Certificate of Appropriateness
BAR #HST25-0055
144 Chancellor Street, Tax Parcel 090109000
The Corner ADC District
Owner: Delta Zeta National Housing Corp.
Applicant: Kevin Blair
Project: Demolition of contributing structure

**City of Charlottesville
Board of Architectural Review
Staff Report
January 22, 2025**

BAR #HST25-0055

RE: 144 Chancellor St.
Initial Structural Condition Assessment
Dunbar Project 2410-72

Photo 1: Imprints of the post in concrete indicate the slabs original position.

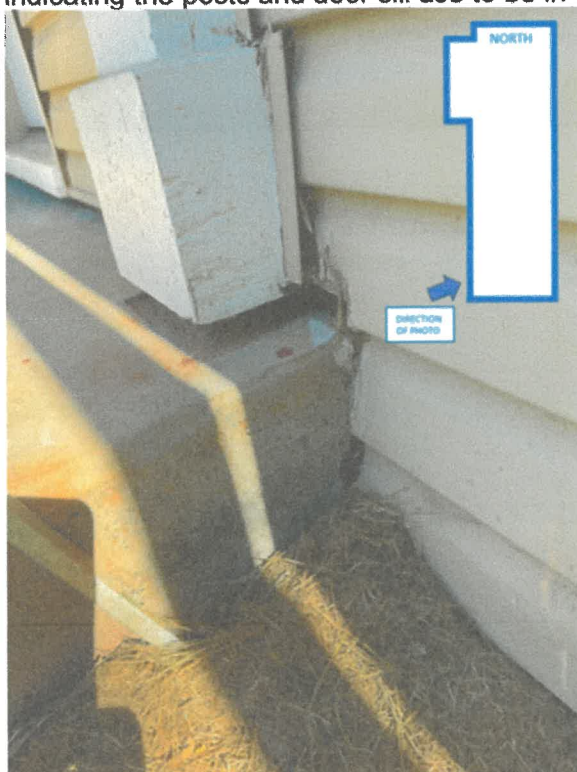
The front porch consists of a 10ft x6ft concrete slab on grade supporting the porches roof. At the building it is apparent that the concrete slab on grade has settled approximately 1 to 2" in elevation. This is apparent in the post imprints in the concrete indicating the posts and door sill use to be in close contact with the concrete slab.

Photo 3: West side retaining wall with significant bow.

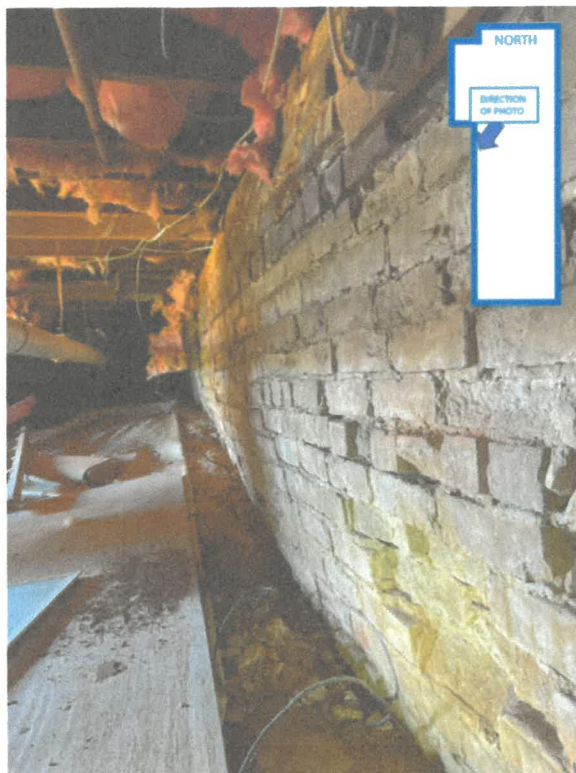
The foundation along the west side of the building consists of a solid brick masonry retaining wall of multi wythe thickness 4 to 5 ft tall within the crawl space. The earth slopes down to the wall from the road which is approximately 15ft from the building at an elevation of 2'-6" above ground floor. The wall is bowed out approximately 3 to 5". It also appears that the top of the wall has shifted laterally. There are numerous horizontal cracks at mid elevation along the wall. Several of the internal brick piers supporting the ground floor are out of vertical by up to 2". The ground within the crawl space appears to be damper than normal considering we have not had any precipitation in the past few weeks.

- The west side brick retaining wall appears to be failing.
- The CMU walls do not appear to be connected at the top and are unstable in the out of plane direction of the wall.
- The slope of the ground is permitting water to build up and infiltrate the west side of the building.

Lateral earth pressure along the west side is displacing the building and causing cracking and failure of the brick retaining wall. This is compounded by water runoff pressing against the wall as well. The presence of horizontal cracks along the mortar as well as the bow in the wall indicates the brick wall is failing in flexure. This bow may be the result of why the slab on grade at the porch has dropped 1 to 2" relative to the ground floor. Indications that all of the brick piers have shifted at the top towards the east (downslope) also indicates that the entire building has shifted downslope as well.

- Excavate and remove the existing backfill along the west side of the building.
- Repair or replace the existing brick retaining wall. This would consist of 35ft of wall.
- Install a foundation subdrain that outlets to daylight or suitable drain. Install a waterproofing system against the below grade walls. Replace backfill along the west wall with an open graded stone such as VDOT No. 57.
- Connect the perimeter CMU infill to the brick masonry piers. This could be accomplished with a 2x ledger board and adhesive anchors.
- Connect the building perimeter sill plate to the CMU infill walls.
- Generally performed repairs to the damaged and cracked masonry. This work would involve extensive repointing.
